Case Number: R18015

Existing Stormwater Asset Map possibly affected by the Proposed Development

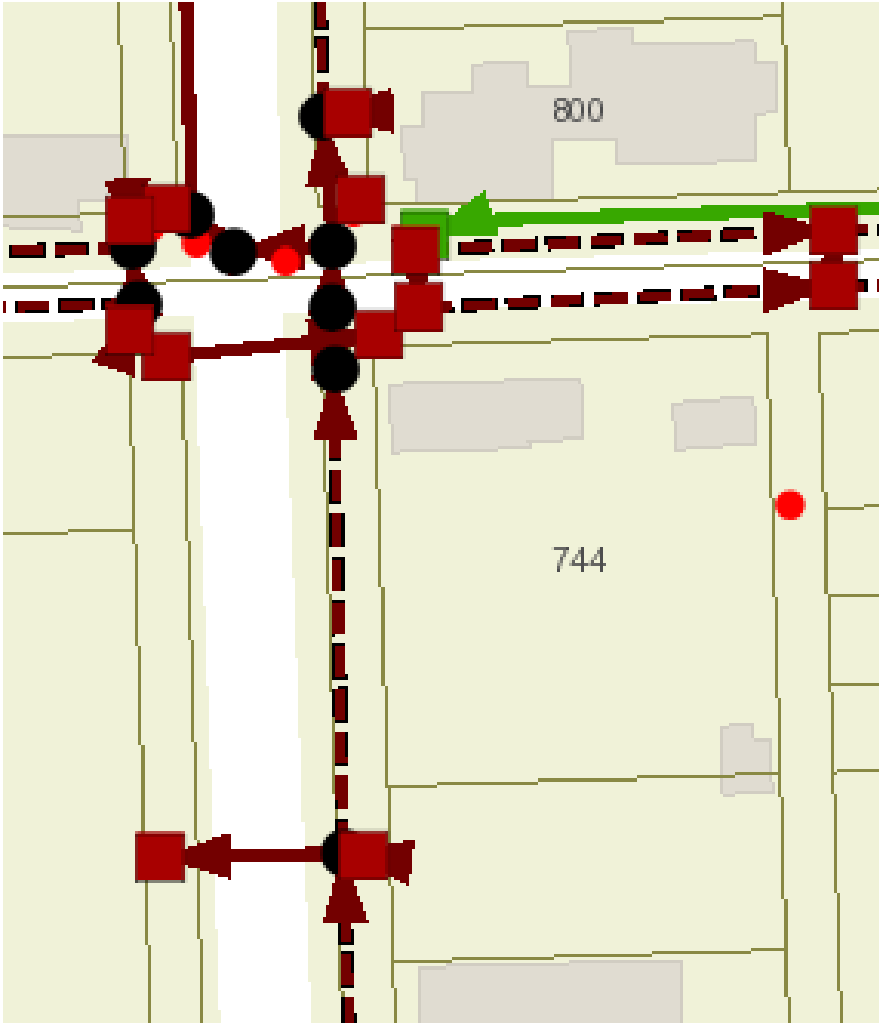
1. Please provide (or revise if already submitted) an erosion, sedimentation, and stormwater pollution prevention plan (**SWPPP**) showing the adjacent City's existing stormwater system as shown in the survey and to the limits shown with green line work in the storm map provided at the end of this report. A copy of the approved SWPP shall be at the construction site from the date of demolition initiation to the date of final construction activities.

- a) Contractor shall provide CCTV videotapes to City STW OPS of the existing stormwater system to the limits shown with green line work in the storm map provided at the end of this report in order to document the PRE and POST construction conditions of the City's storm system.
